**MAINE POWER**  
**RELIABILITY PROGRAM**  
A CENTRAL MAINE POWER COMPANY PROGRAM

November 4, 2010

## Town of Arundel: Request for Additional Information

### **Transmission Line Configuration Cross Sections for Comparison**

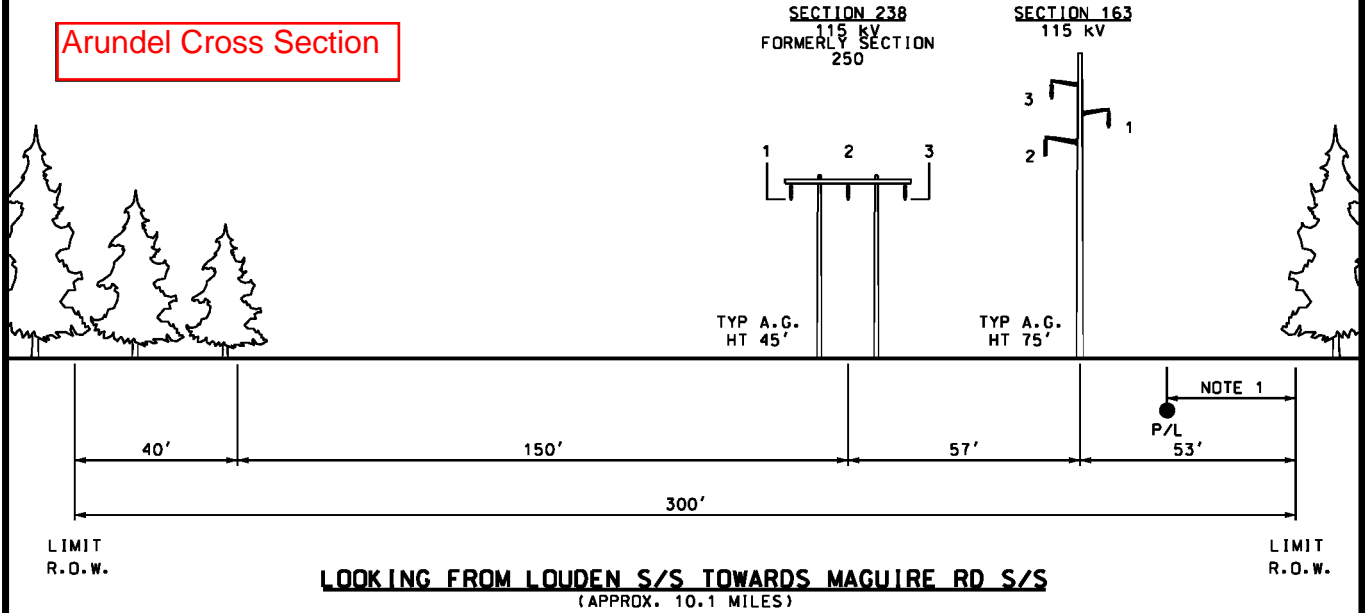
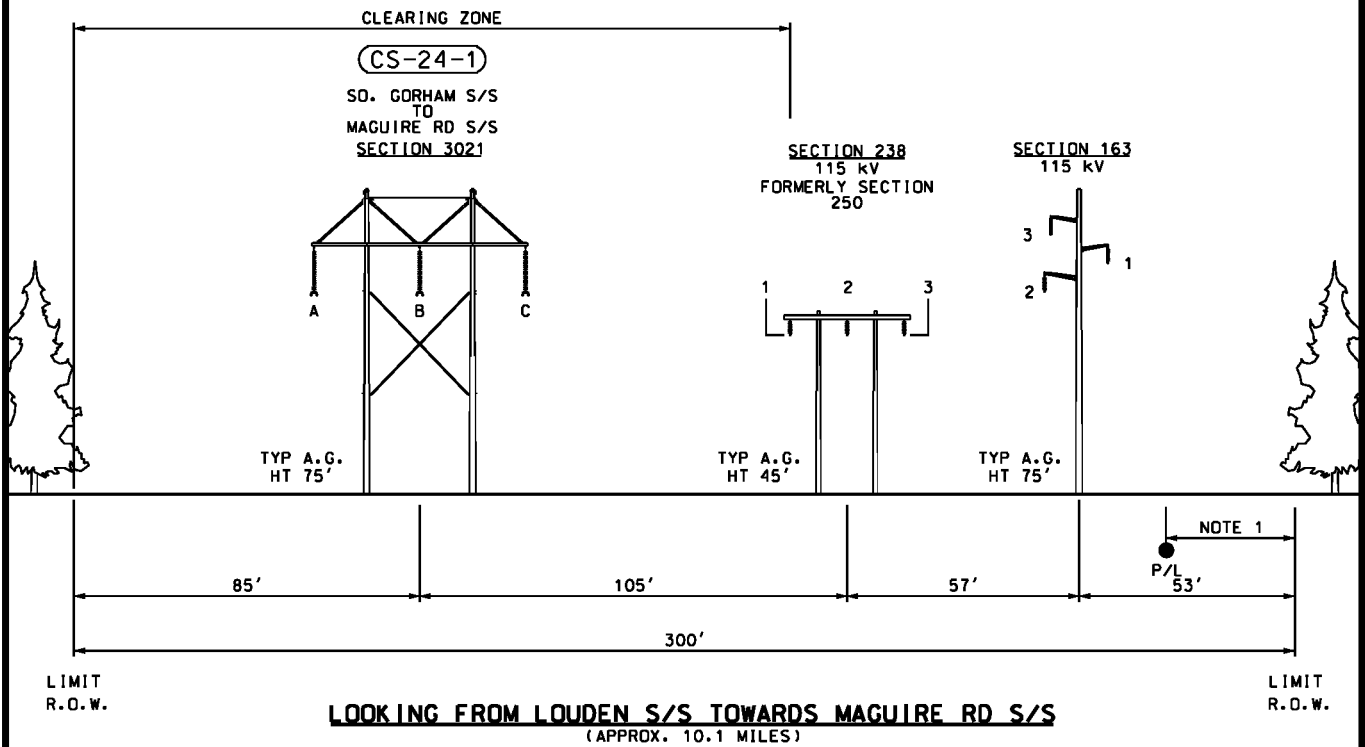
1. *Provide an EMF gradient from 0 to height of conductors at the ROW boundary at each pole and each point of maximum sag. EMF in excess of 4 kV/m has been shown to have a biological effect. See attached document.*

The locations selected for modeling for the MPRP were predominantly areas where clusters of residences abutted the corridor. Since a majority of the proposed project in Arundel is within rural areas, modeling was not performed specifically along the portion of the project that runs through Arundel, but results are available for a portion of the project that is nearly identical in its configuration as what is being proposed in Arundel. The cross section for the portion of the project being used to address EMF is available at Exhibit 2 for comparison.

At the edge of the corridor where the new 345 kV line is proposed, magnetic fields at average loads are estimated to be at 14.4 mG; at peak loads 47.2 mG; and electric fields average 1.21 kV/m for peak and average loads. Two states, New York and Florida have enacted standards for EMF. The magnetic and electric fields for EMF associated with the MPRP are below the standards in Florida and New York, as well as international guidelines recommend by scientific councils. It is important to note that none of the standards at the state level are designed to protect against health effects.
